RE: **Approval of Plans (REV 1)**
TDOT Gibson County Maintenance Building
1248 B Manufacturers Row
Trenton, TN 38382

TFM # 21267
Project # 2023-11-09-02
County: Gibson

Revision #1 Drawing Changes

1 ROOF PLAN

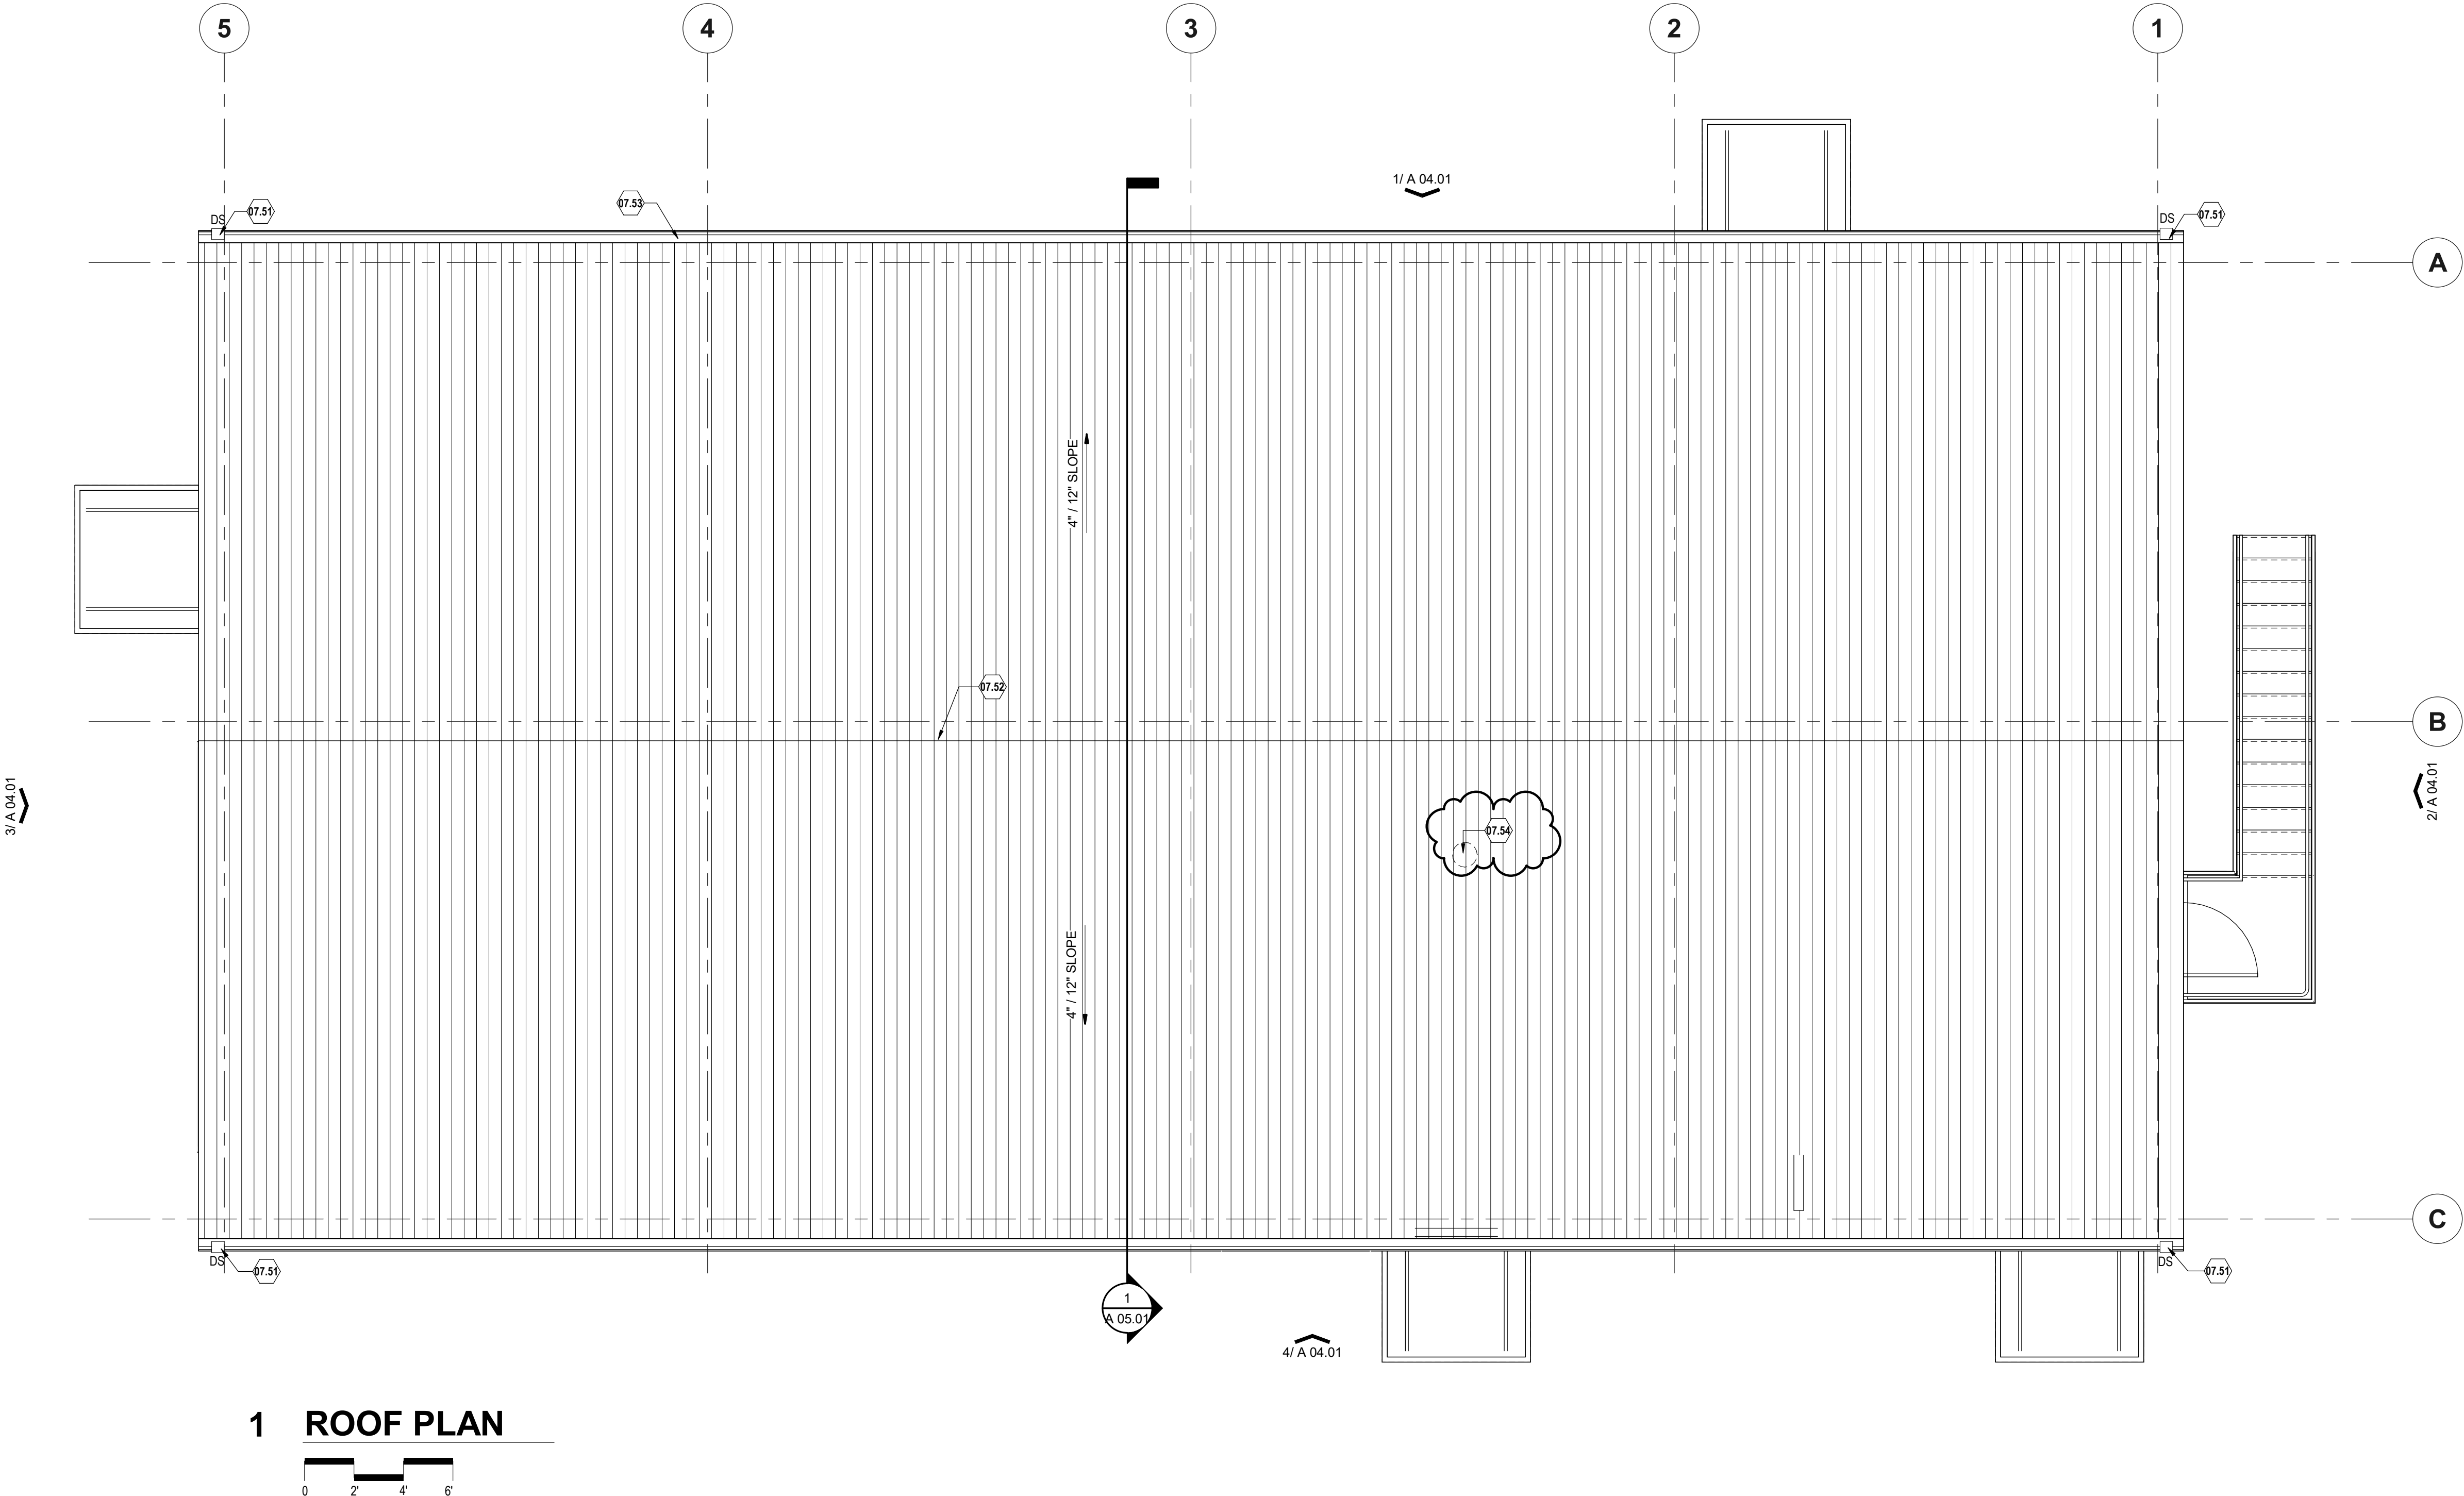
Sheet A02.01: Added roof vent stack

DOORS AND
WINDOWS
DTLS.
A 03.01

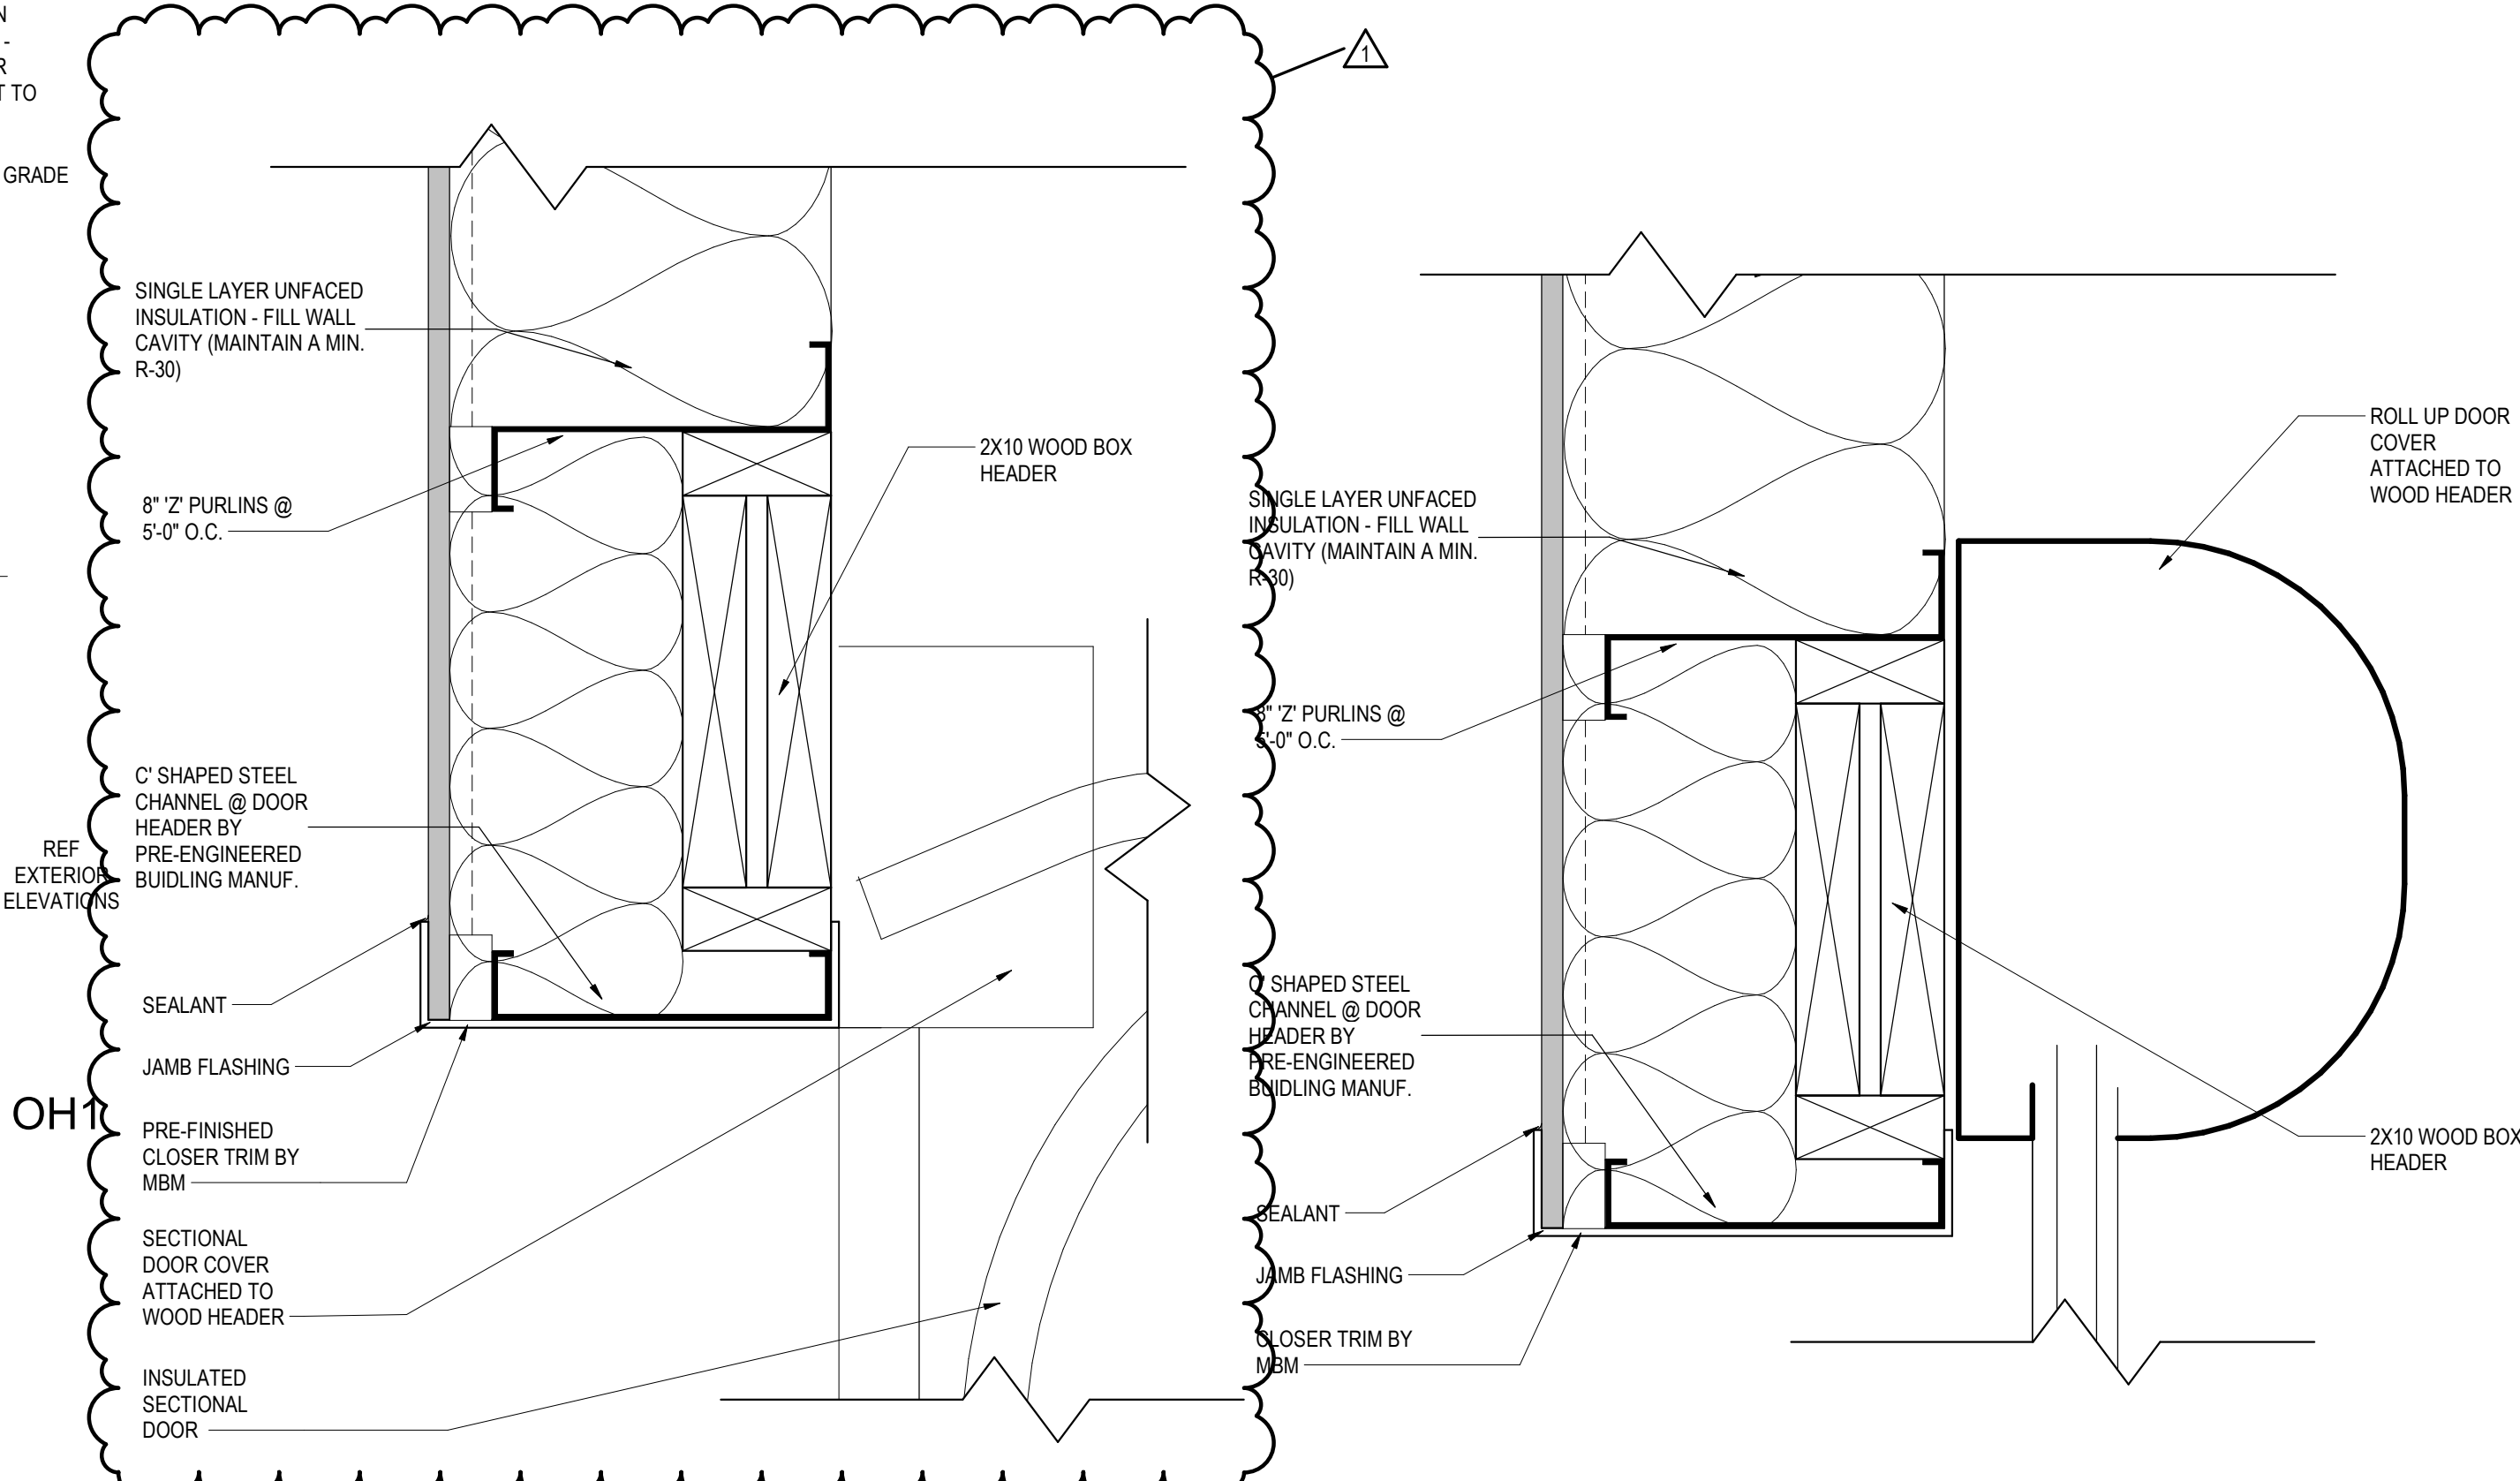
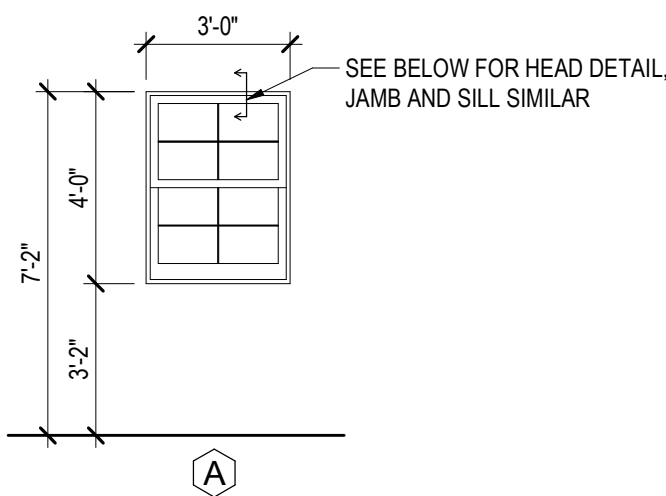
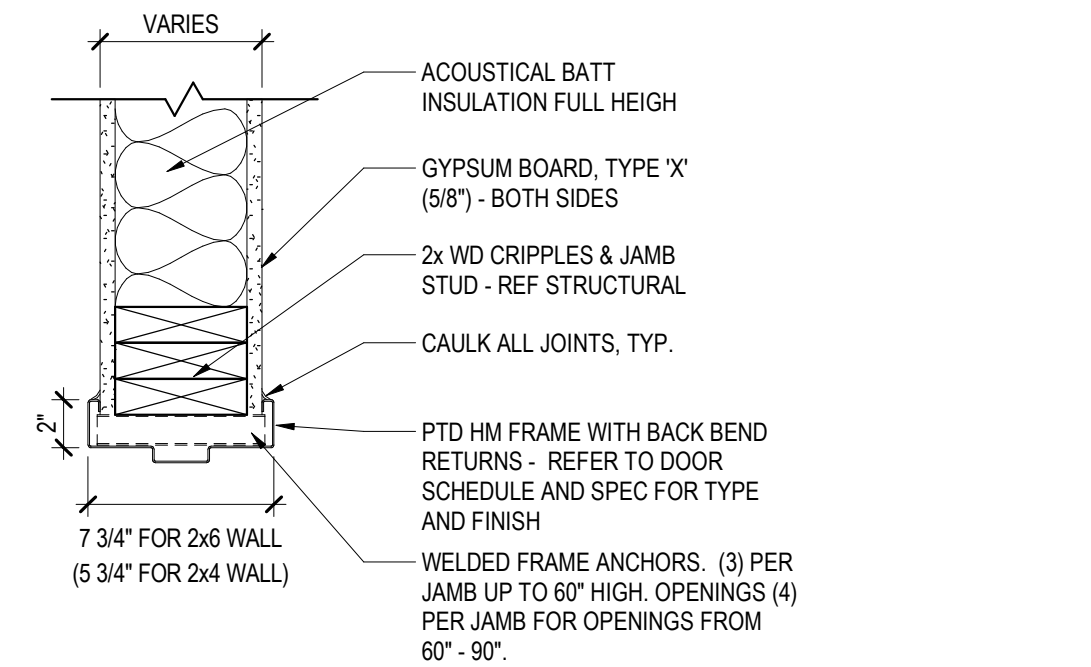
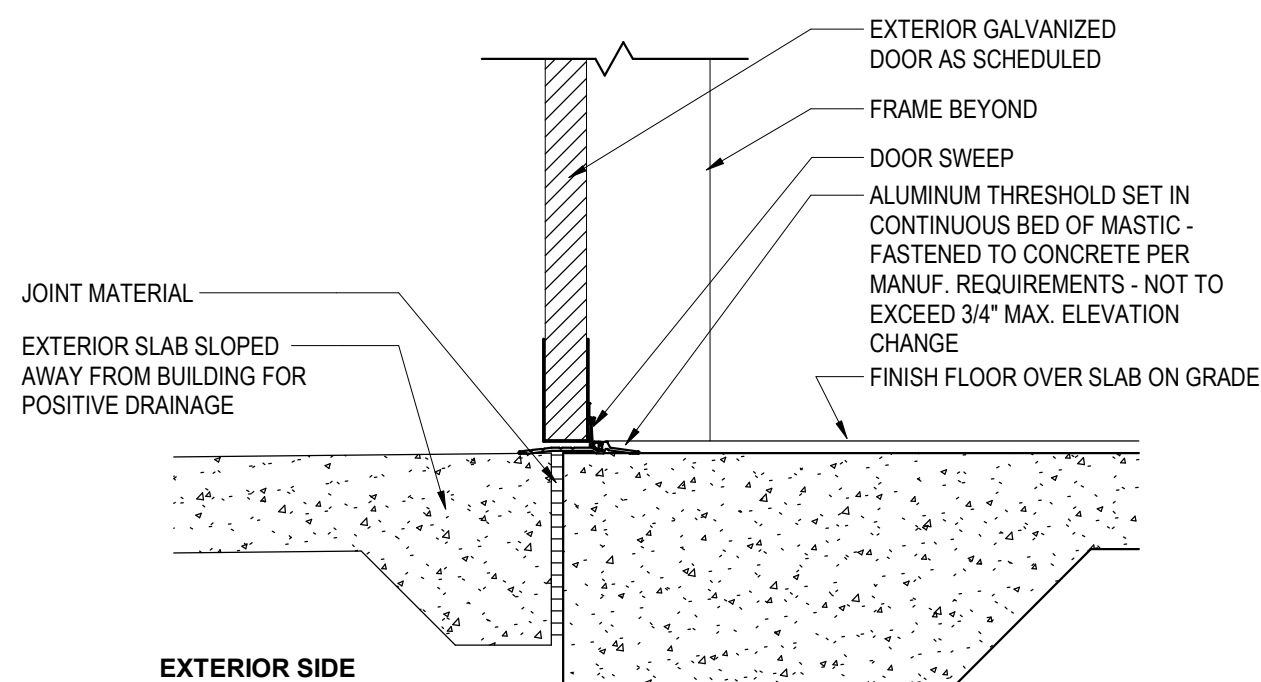
Sheet A03.01: Added a detail for the coiling door, added abbreviations for the doors, and modified the general notes for exterior doors to be type insulated HM.
